Mated Test Fixture Insertion Loss Comment #238

Provide supporting content for D3.0 comment #238 which addresses MTF insertion loss.

CI 179B	SC 179B.4.1	P 909	L 11	# 238
Heck, Howard		TE Connectivity		
Comment Type	TR	Comment Status	D	ILdd fit (E)
<p>Prior contributions (e.g. https://ieee802.org/3/dj/public/26_03/lusted_3dj_02a_2603.pdf) have proposed tightening the range of the min/max specs by using fitted insertion loss and accounting for differences between the fitted insertion loss of an actual test fixture and the reference insertion loss.</p>				
<i>Suggested Remedy</i>				
<p>Change page 909, line 18 to ILdd(f) is the fitted insertion loss in dB at frequency f</p>				
<p>Change page 907, line 32 to The effects of differences between the fitted insertion loss of an actual test fixture and the reference insertion loss are to be accounted for in the measurements.</p>				
<p>A supporting presentation is planned.</p>				
<i>Proposed Response</i>	<i>Response Status</i> W			
<p>PROPOSED ACCEPT IN PRINCIPLE. The comment aligns with the direction of the straw poll following the discussion at the March Plenary <https://www.ieee802.org/3/dj/public/26_03/motions_3dj_2603.pdf>. Further

Differential Insertion Loss

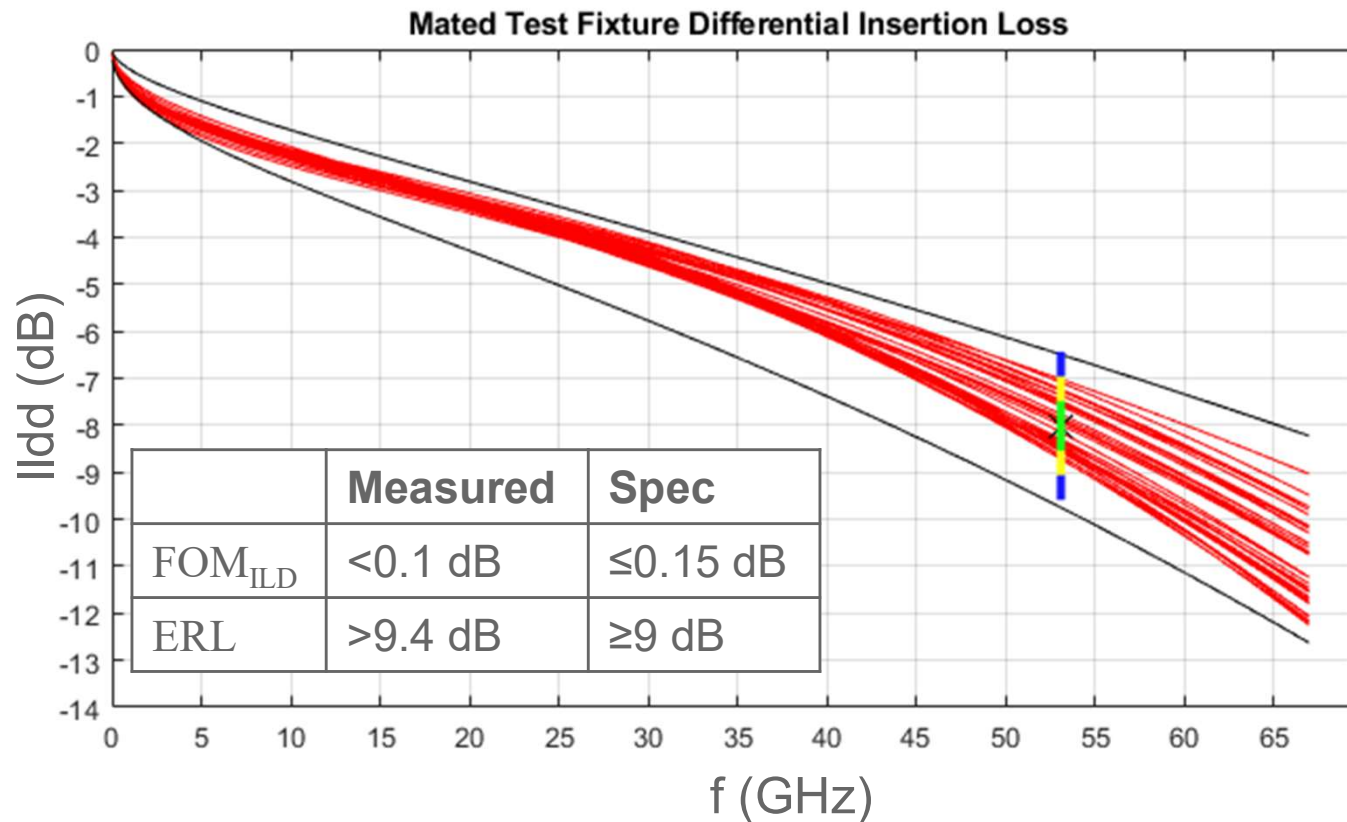
- Data for mated test fixtures from two suppliers.
- Excursions exist beyond the insertion loss limits.

Reference Insertion Loss S-Parameter Determination

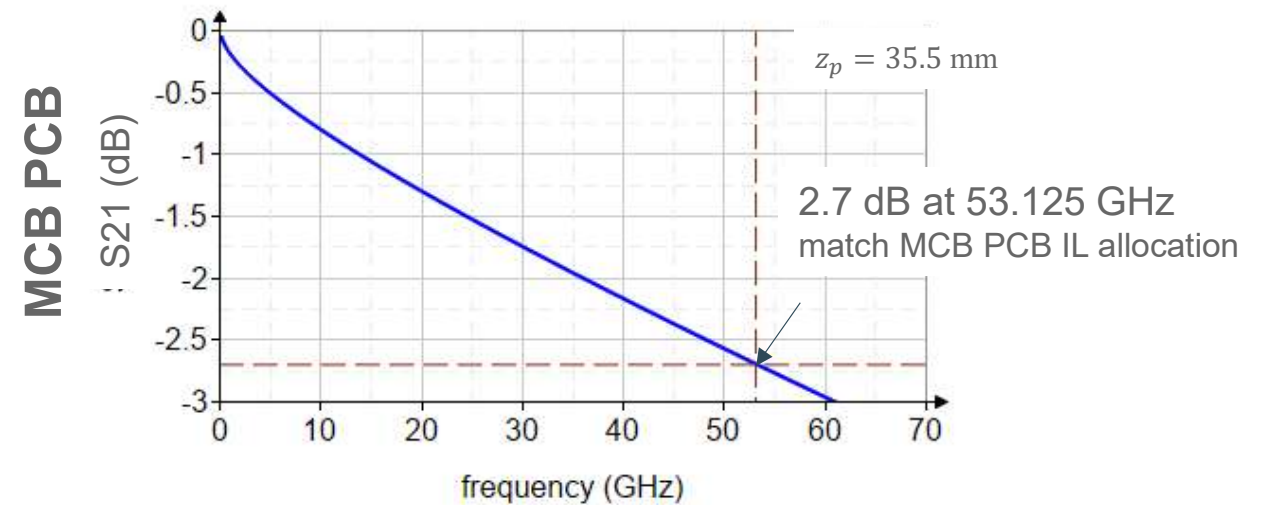
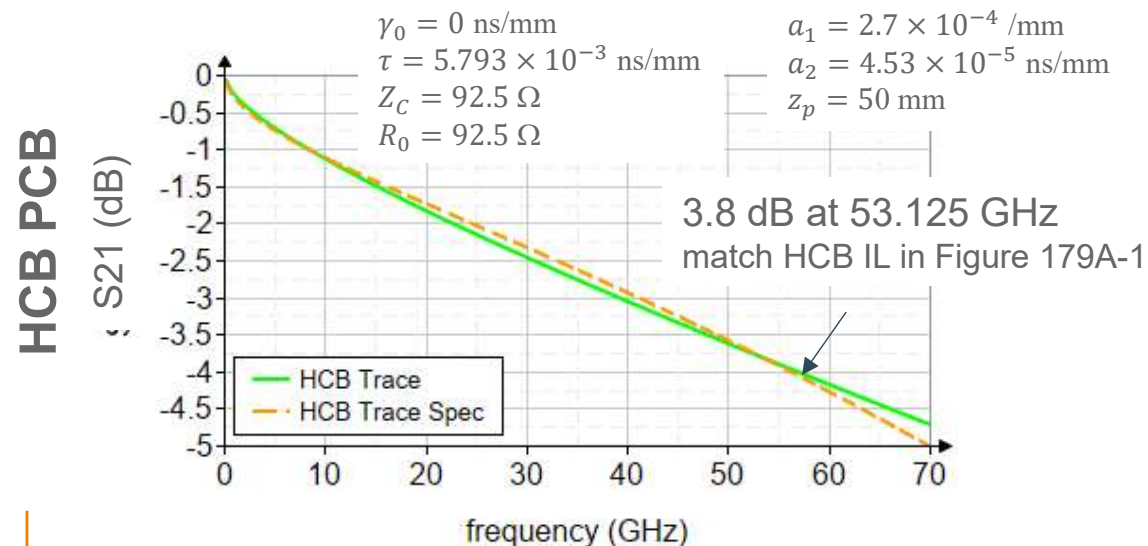
- Apply the transmission line S-parameter equations in 93A.
 - (93A-9) thru (93A-12) and (93A-14)
- HCB: Adjust a_1 , a_2 , z_p to match the reference curve in Figure 179B-1 & Equation (179B-1).
 - Match the $f^{1/2}$ shape at lower frequencies and match the insertion loss at 53.125 GHz.
- MCB: Adjust z_p to match the 2.7 dB MCB PCB insertion loss allocation (at 53.125 GHz).
 - D3.0 specifies 4.95 dB for trace + via + connector (Figure 179A-1). Allocated as 2.7 dB for trace and 2.25 dB for connector + via. (Refer to Figure 179A-1 in D1.4)
- Connector: We have no reference connector, therefore no reference S-parameters.
 - Without connector reference parameters, the benefit of this method doesn't justify implementation. We do not recommend adopting this approach.
